CORNBROOK RESIDENTIAL DEVELOPMENT

NON-MATERIAL AMENDMENT TO PLANNING APPLICATION 118625/FO/2017

LIST OF AMENDMENTS AND SUPPORTING INFORMATION

Enhancements to residential entrance - visual

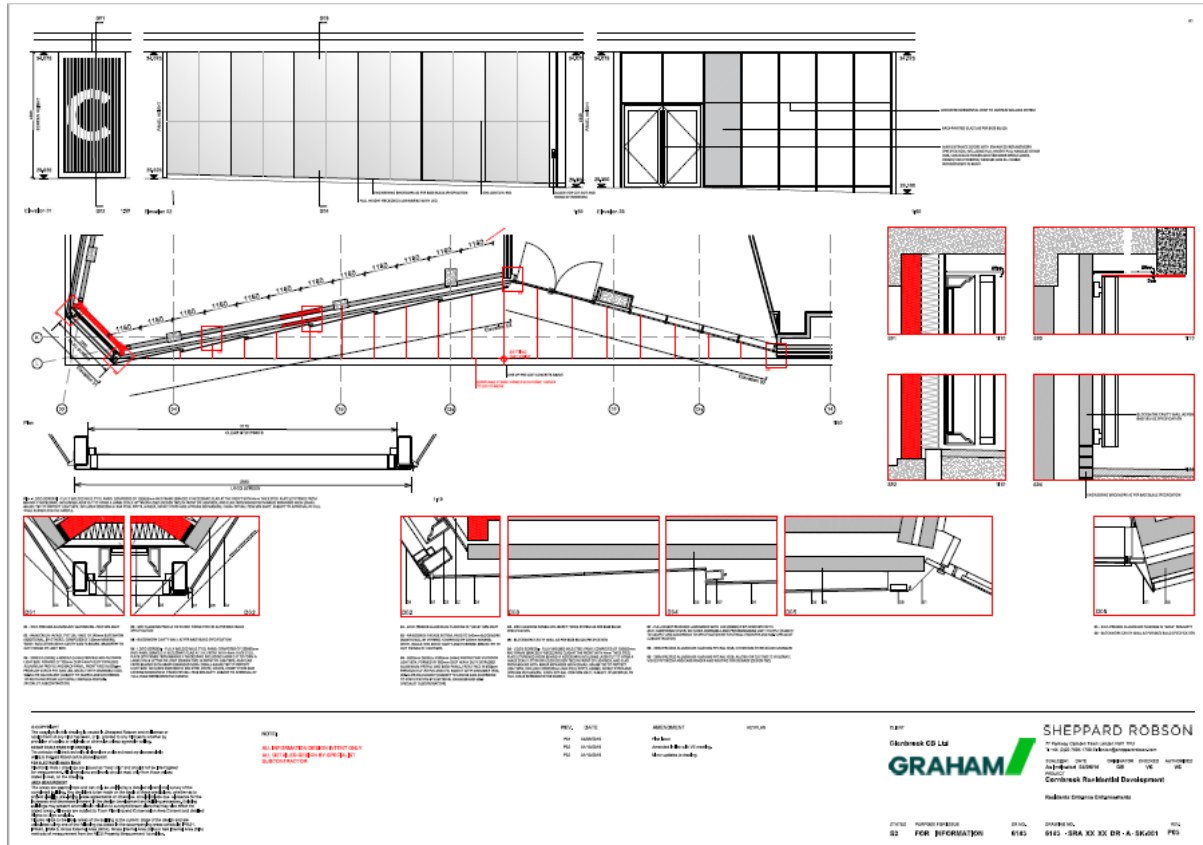
Further to discussions with the prospective retailer and the Client, it became apparent that the GF corner of the building facing Ellesmere Street would be of greater urban relevance if integrated in the approach to the main entrance, rather than offering a subsidiary view into the retail unit. We propose an amendment of this aspect, creating a building sign integrated with the architectural language of the building, supplemented with a subtle variation to the cladding line and the introduction of vertical strips of accent lighting.

Revised car park enclosure – with original planting

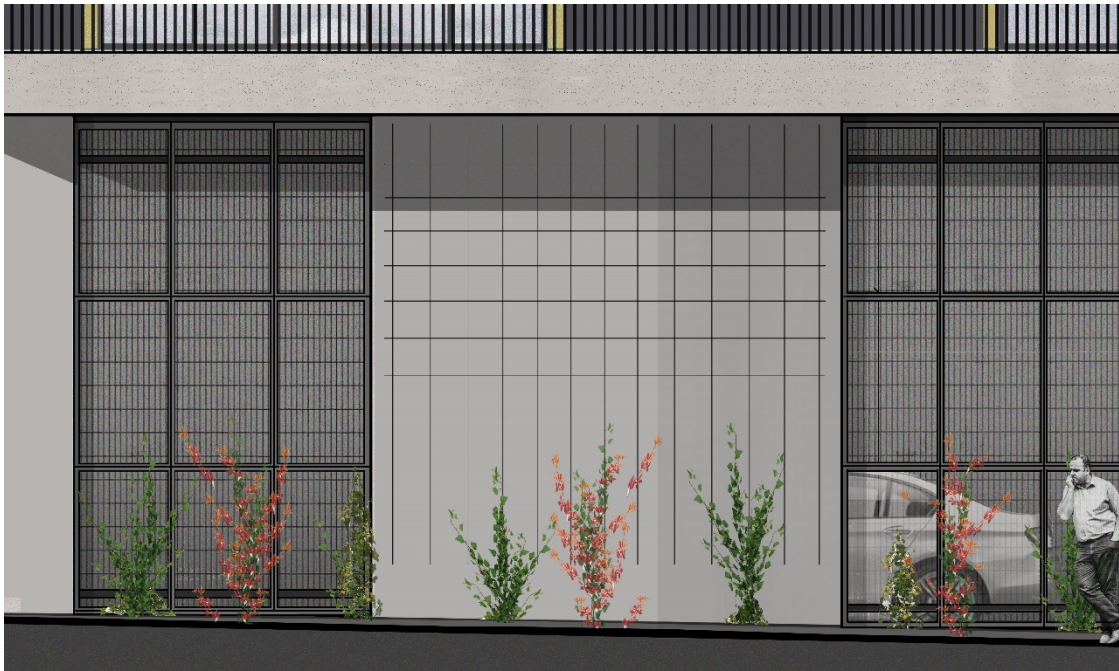
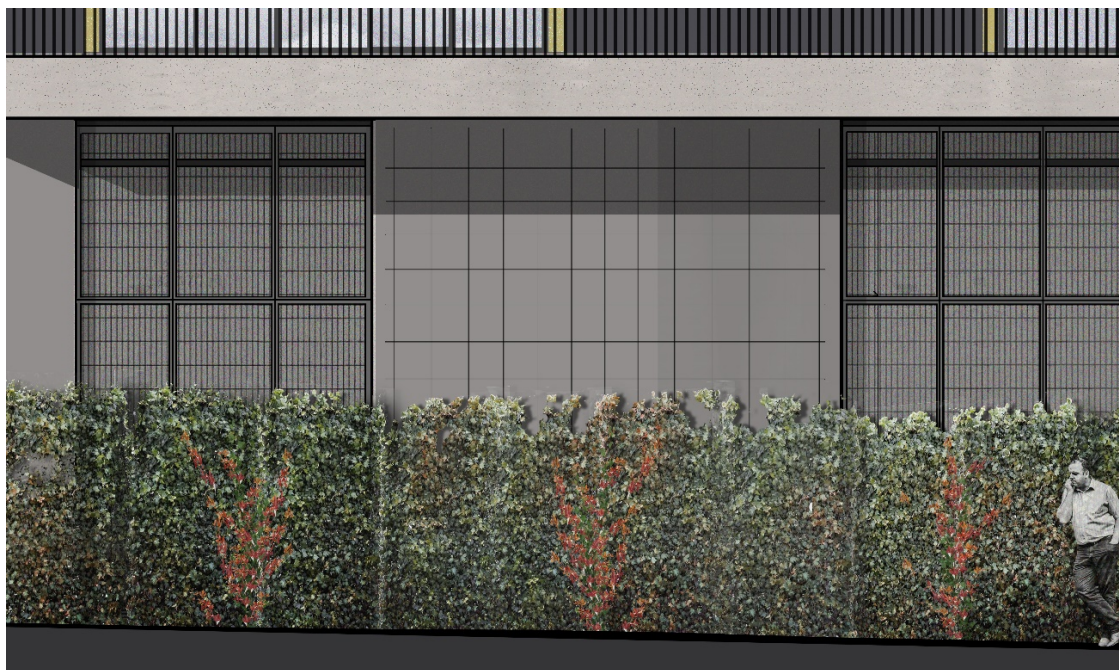
Still at Ground Floor level, a recent change in the assessment methodology for risk of fire spreading within and out of car parks determined the need to increase the percentage of fire rated enclosure to the undercroft. We propose to provide this through the introduction of full-height precast concrete panels, following the materiality and language of the facades. In order to mitigate the visual impact of these elements at practical completion, we propose to upgrade the original planting scheme, introducing a screen of semi-mature ivy panels, supplemented with younger climbers to add interest and seasonal variety.

Rooftop canopy visibility study

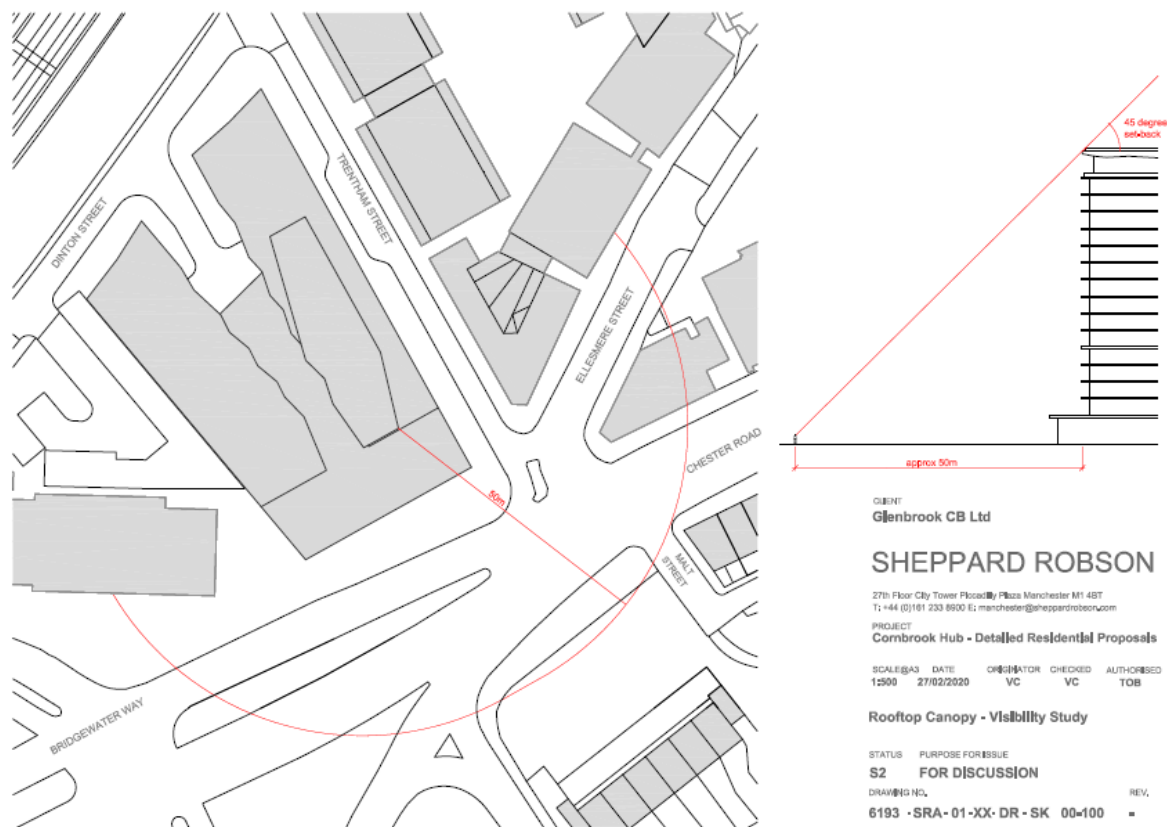
Further to a detailed design of the structure and coordination with M&E services installation, we also propose an adjustment to the height and depth of the rooftop slabs and parapets, as per the drawings submitted. In order to maintain the slim edge of the rooftop profile in accordance with the original design, we propose a slight overhang to the eaves and setting back of the parapet to a line of 45 degrees. Graphical evidence of the impact of this amendment is provided in the images below.
